## **Amendments to the Drawings**

App. No.: 10/082,567

Response to Office Action filed August 20, 2003 re: U.S. App. No. 10/082,567

App. No.: 10/082,567
Atty Dkt No.: 1458.TT4763
Inventor: Tom Tse et al.
Atty: J. Gustav Larson (512) 327-5515
ANNOTATED MARKED-UP DRAWING
0/1

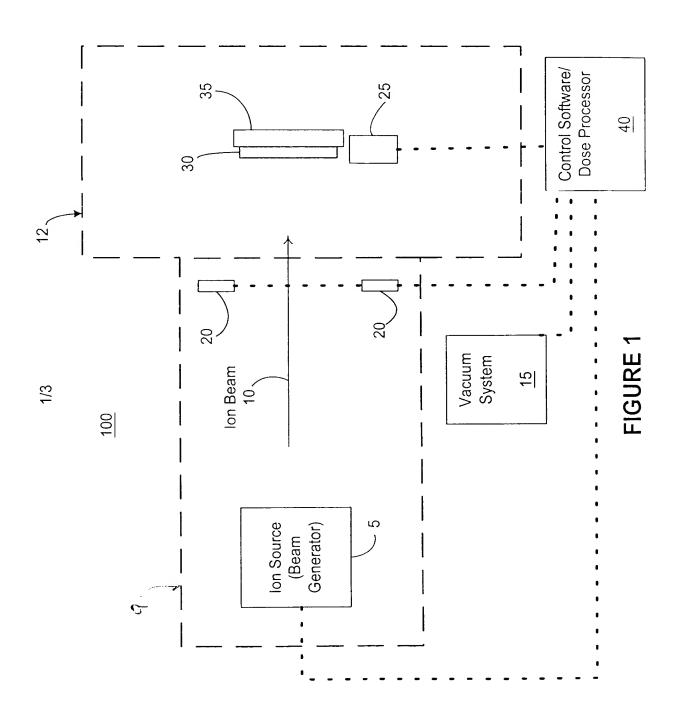
The attached Appendix includes an Annotated Marked-up Drawing of FIG. 1 and a Replacement Sheet, including FIG. 1. In FIG. 1, previously omitted element 9 has been added, as requested by the Office.
